MAINE TURNPIKE AUTHORITY

ADDENDUM NO. 1

CONTRACT 2018.19

BRIDGE REPLACEMENT

SHEET NUMBER: EQ-01

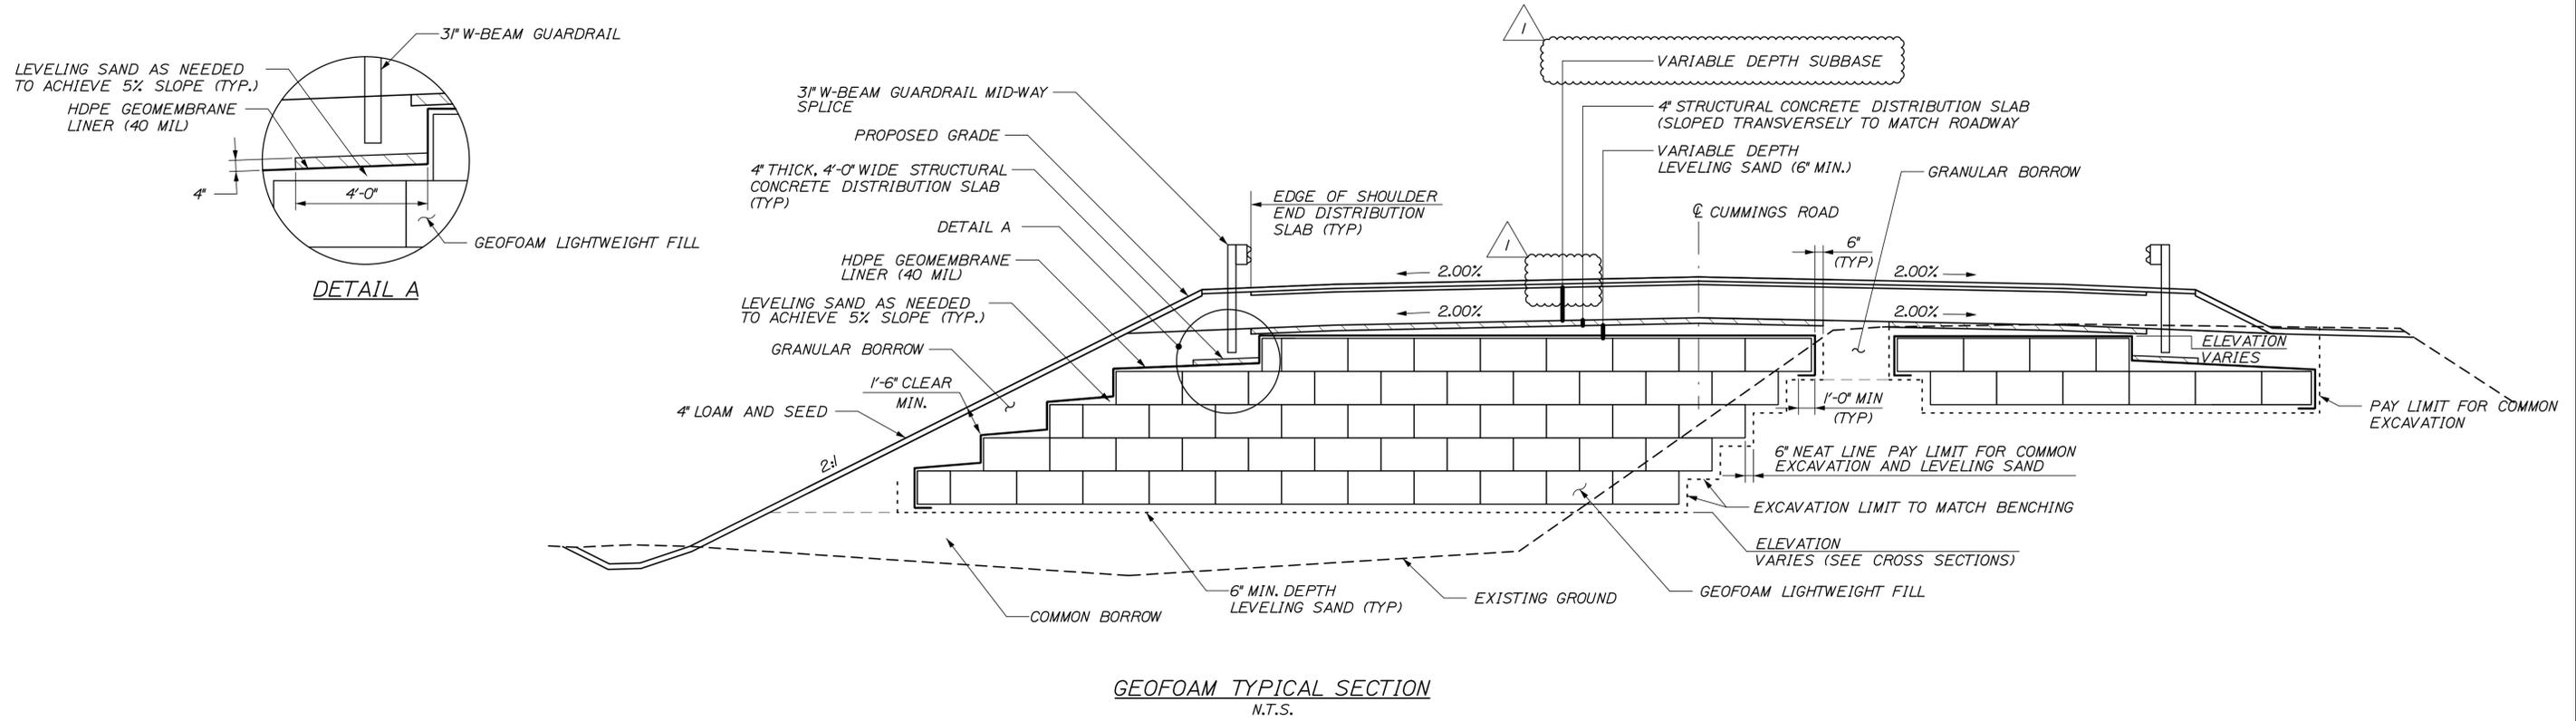
Plan Sheet EQ-01, sheet 2 Estimated Quantities, is being reissued for revisions to Items 203.45 Leveling Sand, 304.10 Aggregate Subbase Course Gravel and 652.38 Flaggers.

SHEET NUMBER: TYP-02

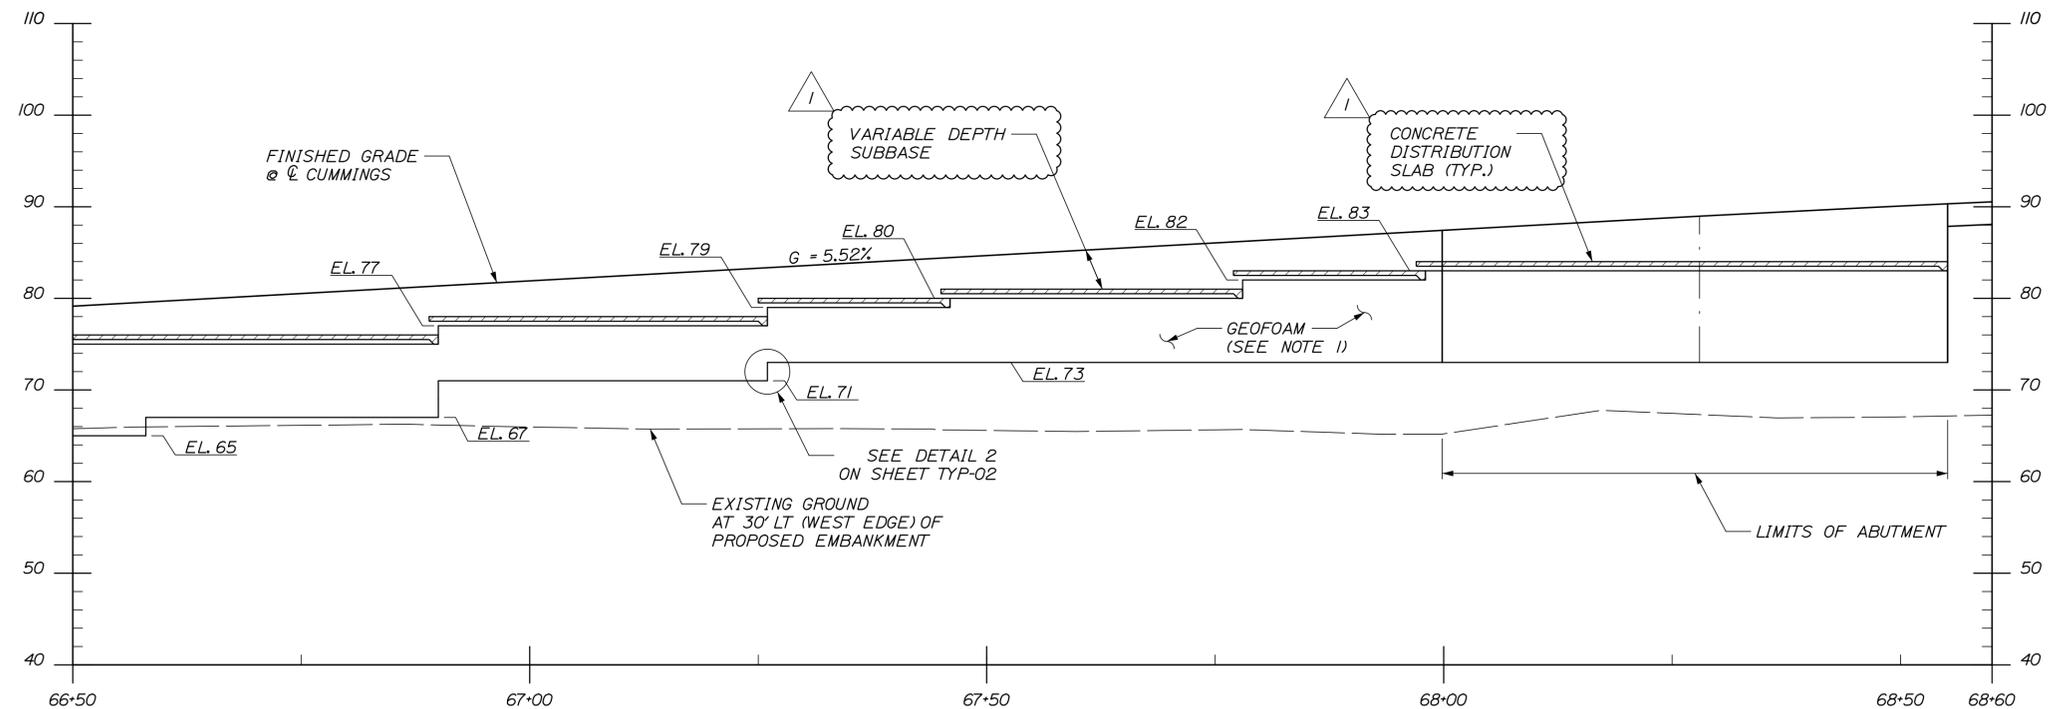
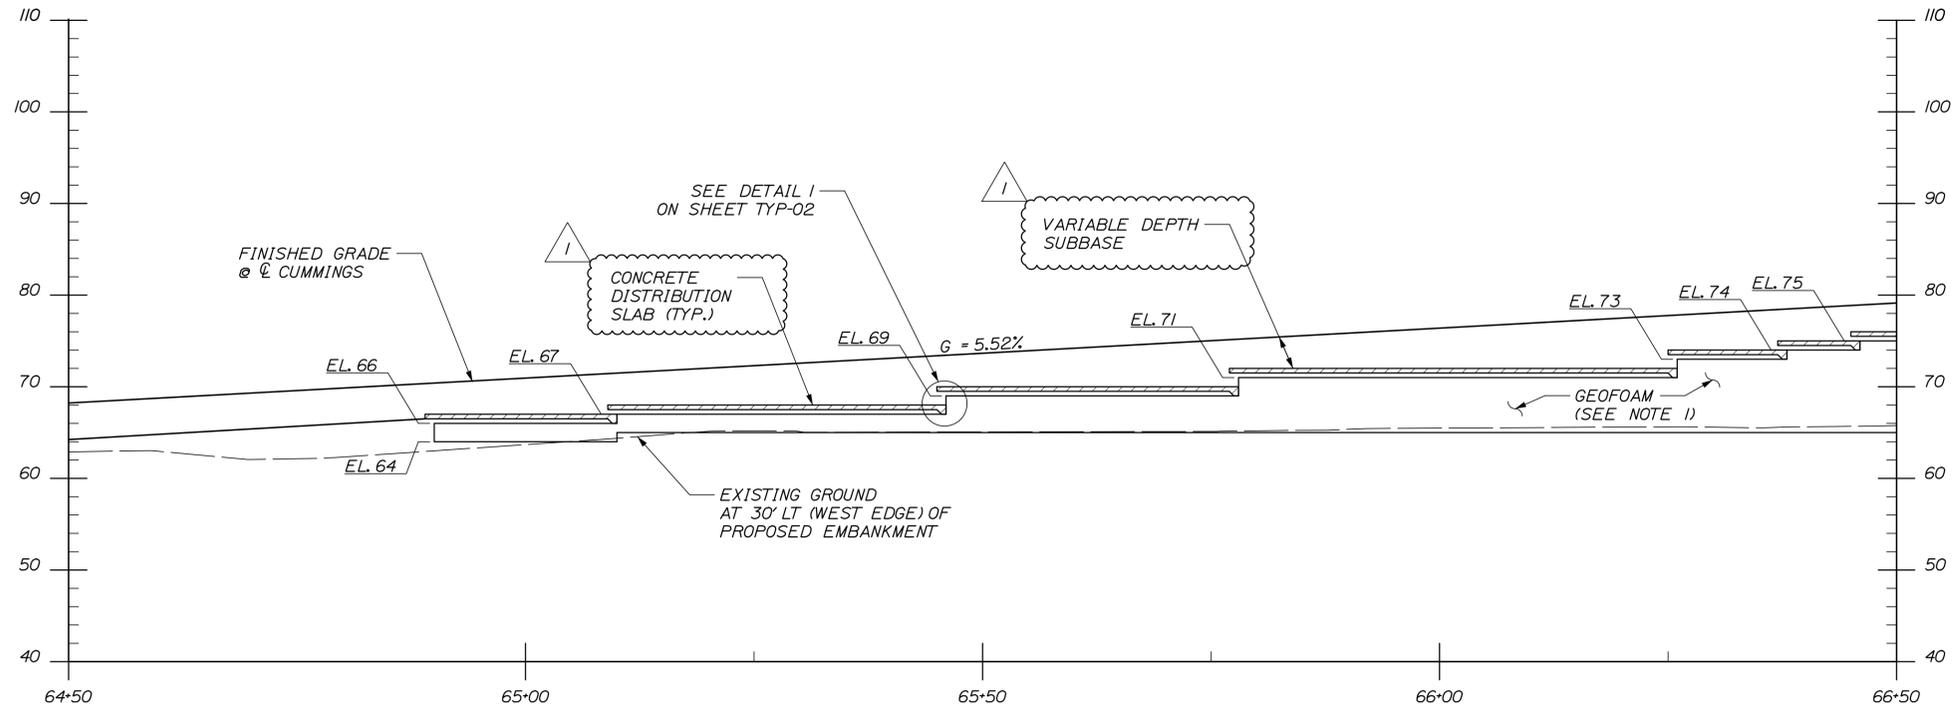
Plan Sheets TYP-02, sheet 6 Geofoam Special Details and GT-01 and GT-02, sheets 64 and 65 Geofoam Longitudinal Profiles, are reissued to clarify and include a depiction of longitudinal extents of the concrete distribution slab.

Question 1: Page 6 shows a 4” thick concrete distribution slab and refers to Sheets GT-01 and GT-02 but doesn’t define the longitudinal limits of the slab. Can you clarify the longitudinal limits?

Answer: The concrete distribution slab shall generally be installed above the top layer of geofoam blocks within the paved width of the embankment and extend longitudinally 6” beyond the edge of geofoam. Plan Sheets Typ-02, GT-01 and GT-02 are reissued with this Addendum for additional clarity.
